## *City of El Paso – City Plan Commission Staff Report*

**Case No:** SUSU15-00082 Desert Springs Unit Four  
**Application Type:** Major Combination  
**CPC Hearing Date:** January 28, 2016  
**Staff Planner:** Armida Martinez, (915) 212-1605, [martinezar@elpasotexas.gov](mailto:martinezar@elpasotexas.gov)  
**Location:** North of Transmountain and East of I10  
**Acreage:** 63.076 acres  
**Rep District:** 1  
**Existing Use:** Vacant  
**Existing Zoning:** R-3A (Residential)  
**Proposed Zoning:** R-3A (Residential)  
**Nearest Park:** Desert Springs Unit 2 Park (.15 miles)  
**Nearest School:** Alderete Middle School (1.30 miles)  
**Park Fees Required:** None  
**Impact Fee Area:** Westside Impact Fee Area  
**Property Owner:** DVEP Land LLC  
EP Transmountain Residential LLC  
City of El Paso  
**Applicant:** DVEP Land LLC  
**Representative:** CEA Group

**PRELIMINARY PLAT**

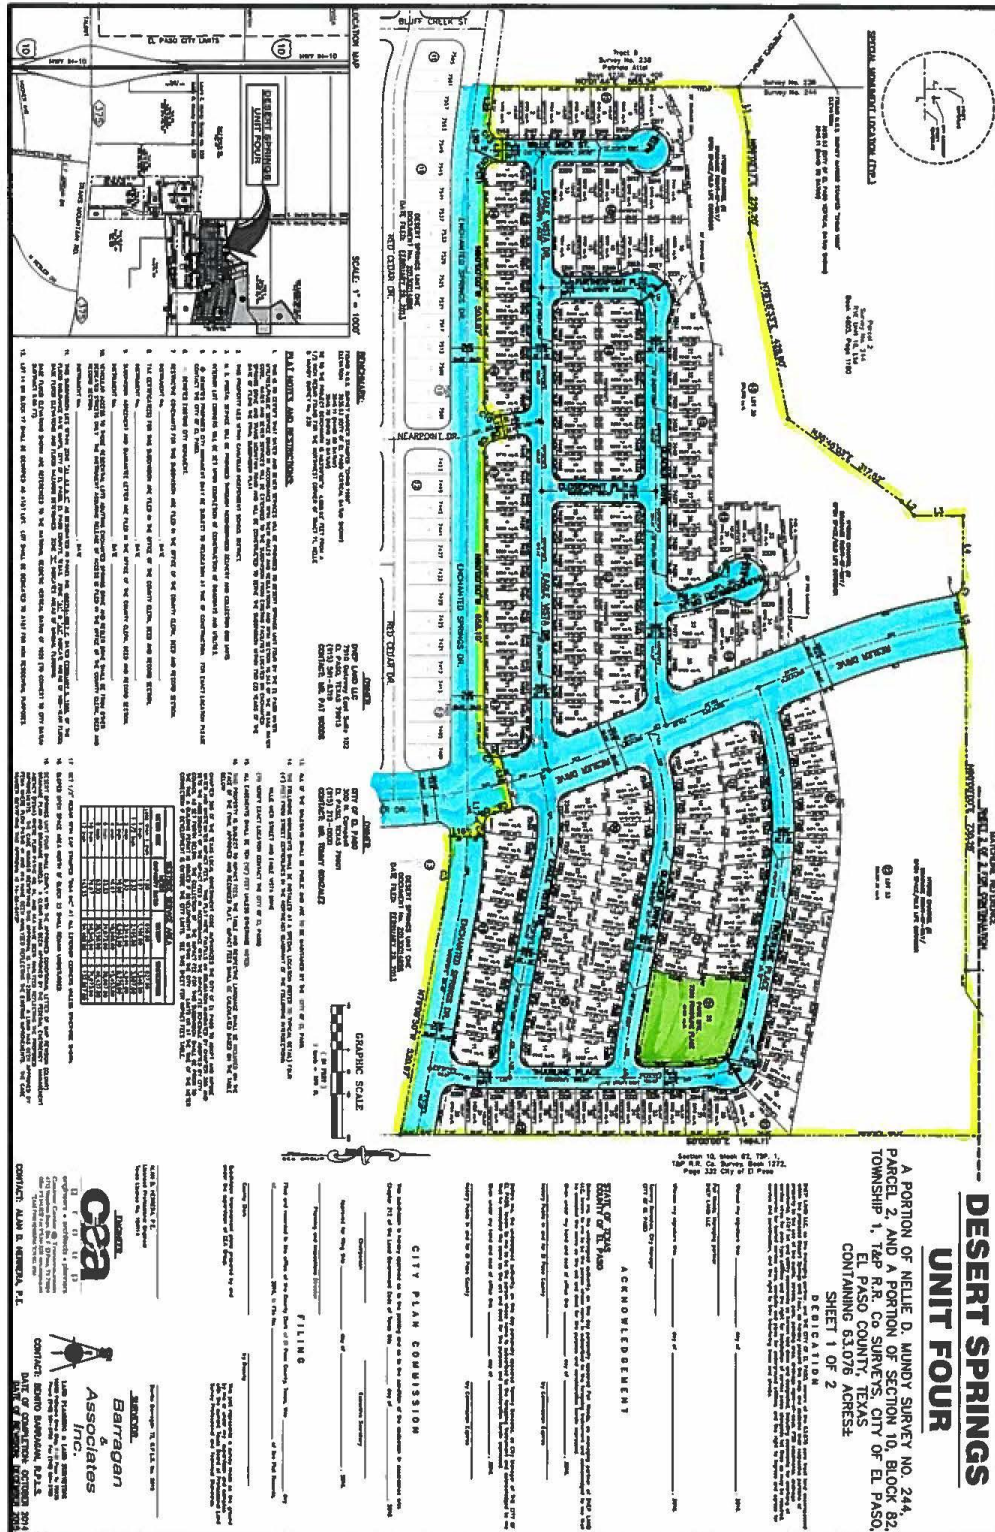
1. Submit to the Planning & Inspections Department – Planning Division the following prior to recording of the subdivision.
  - a. Current certified tax certificate(s)
  - b. Current proof of ownership
  - c. Release of access document, if applicable
  - d. Set of restrictive covenants, if applicable
2. Every subdivision shall provide for postal delivery service. The subdivider shall coordinate the installation and construction with the United States Postal Service in determining the type of delivery service for the proposed subdivision. In all cases, the type and location of delivery service shall be subject to the approval of the United States Postal Service.
3. Verify minimum lot widths as there are multiple lots that do not meet the minimum lot width for R-3A.
